# IDAP REPORT

<b>Property:</b>	21 James Street STRATHFIELD SOUTH LOT 3 DP 15647 DA2022/58
<b>Proposal:</b>	Construction of a two storey dwelling
<b>Applicant:</b>	Allcastle Homes Pty Ltd
<b>Owner:</b>	R Chong / L Lim
<b>Date of lodgement:</b>	17 March 2022
<b>Notification period:</b>	25 March 2022 to 08 April 2022
<b>Submissions received:</b>	Nil
<b>Assessment officer:</b>	P Santos
<b>Estimated cost of works:</b>	\$548,351.00
<b>Zoning:</b>	R2-Low Density Residential - SLEP 2012
<b>Heritage:</b>	N/A
<b>Flood affected:</b>	Yes
<b>RECOMMENDATION OF OFFICER:</b>	<b>APPROVAL</b>

Figure 3. Submitted landscape plan.

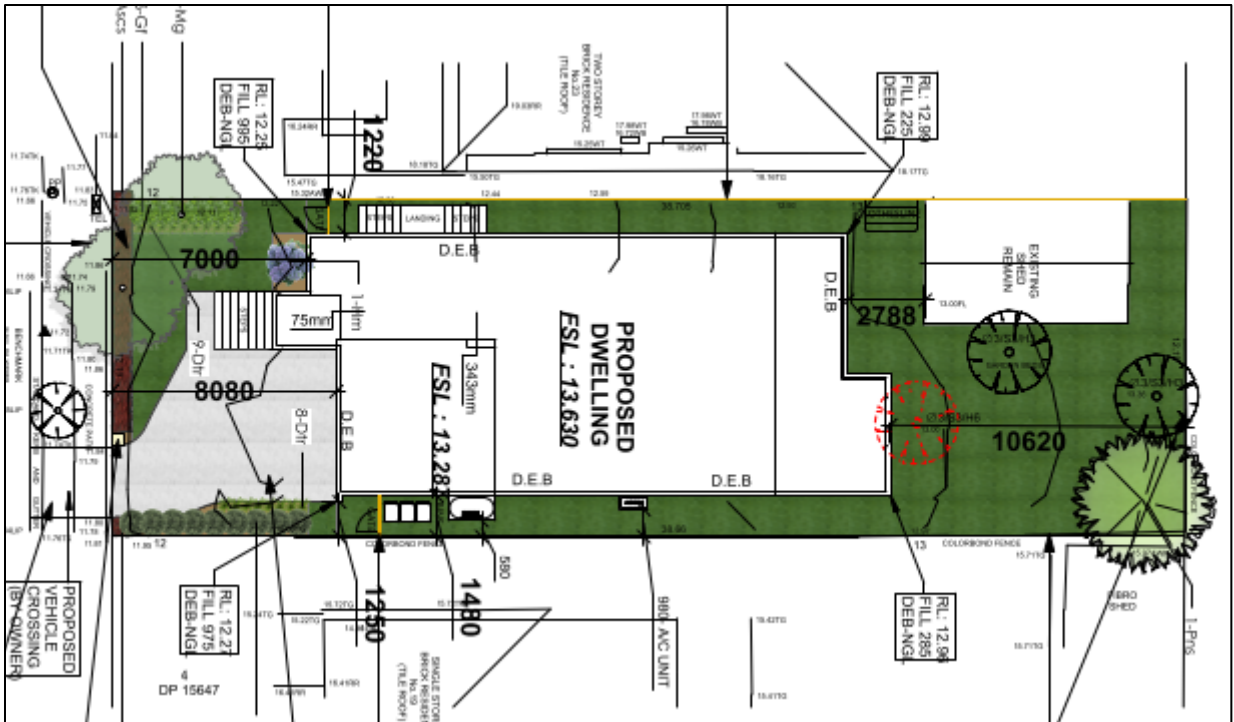
The proposed development involves inadequate landscaping proposed on the site. The SCDGP 2005 requires at least 35% (165.2m<sup>2</sup>) landscaping and the proposal has 32% (150.9m<sup>2</sup>), a shortage of 14.3m<sup>2</sup> or 8.7% variation.

Notwithstanding the non-compliance above, the proposal is considered acceptable. The proposed variation is considered negligible given the several factors that contribute to the non-compliance and it is considered it would be unreasonable for Council to require satisfaction of the development control.

The site is narrow with only 12.19m in width. The dwelling house is required to have at least 1.2m side setbacks on both sides. Note that Council excludes any landscaping within the side setback if it is 1.5m or less, as such, the narrowness of the lot contributes as to why the proposal cannot meet the required landscaping.

Further to the above, the existing garage which is to be used as a shed, will be retained. The 33m<sup>2</sup> outbuilding contributes to the backyard having inadequate landscaping. It is noted that the house does not have an alfresco to not increase the non-compliant landscaping any further. And maintaining a balance between the occupants' right to have an adequate

Figure 6. Extract of the southern elevation (front).

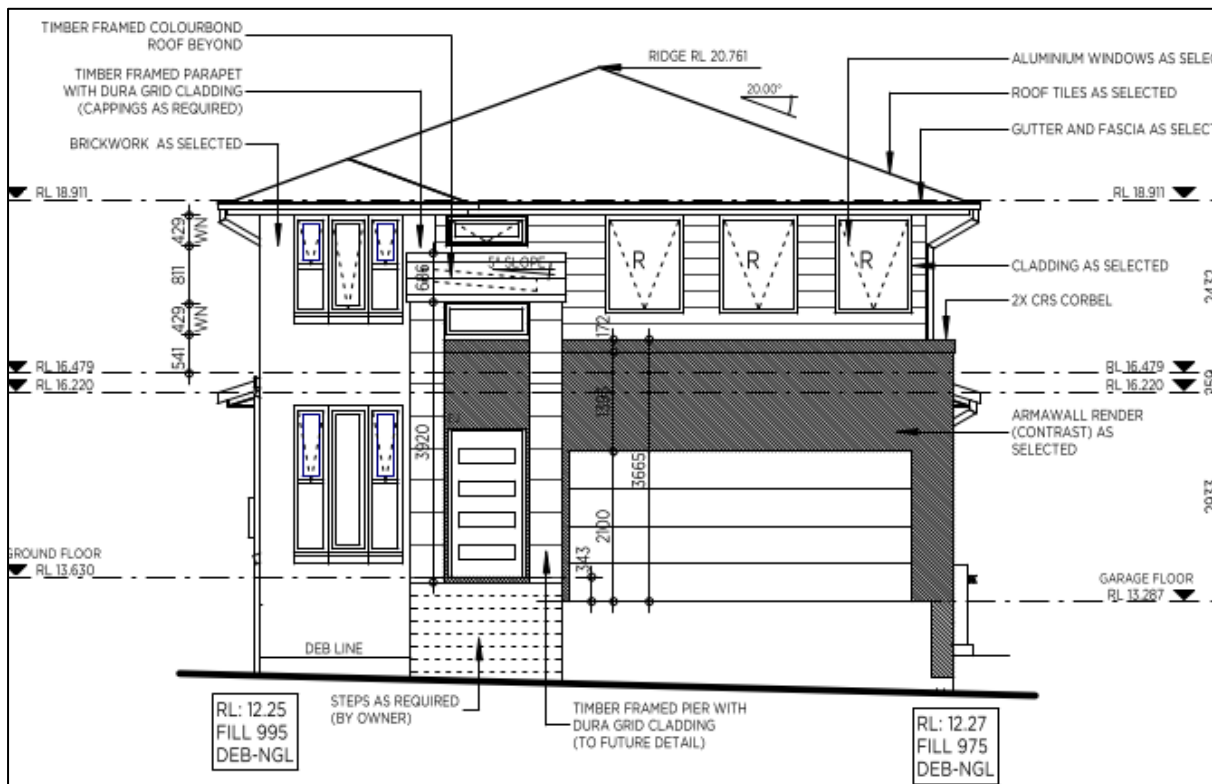
In this case, a lesser setback can be permitted as the front setback of the existing dwelling is less than 9m. However, it is noted that the existing dwelling, utilising the survey plan submitted to Council, has a front setback of 6.2m and the proposed dwelling has a front setback of 6m (measured from the posts of the porch), which presents a 200mm shortfall to capitalise on the concession. As such, a condition of consent is imposed to increase the front setback of the posts of the porch to be 6.2m – an increase of 200mm.

Amendments made in red on approved plans	All changes made in red on the approved plans shall be updated and shown on the Construction Certificate plans.
Front Setback	The front porch, including the supporting posts, is to have its depth reduced by 200mm to increase the development's front setback to 6.2m.
Landscape Plan	The landscape plan is to be amended to reflect the changes made to the approved floor plans, in particular the steps at the front of the porch to reflect the lowered front part of the house.
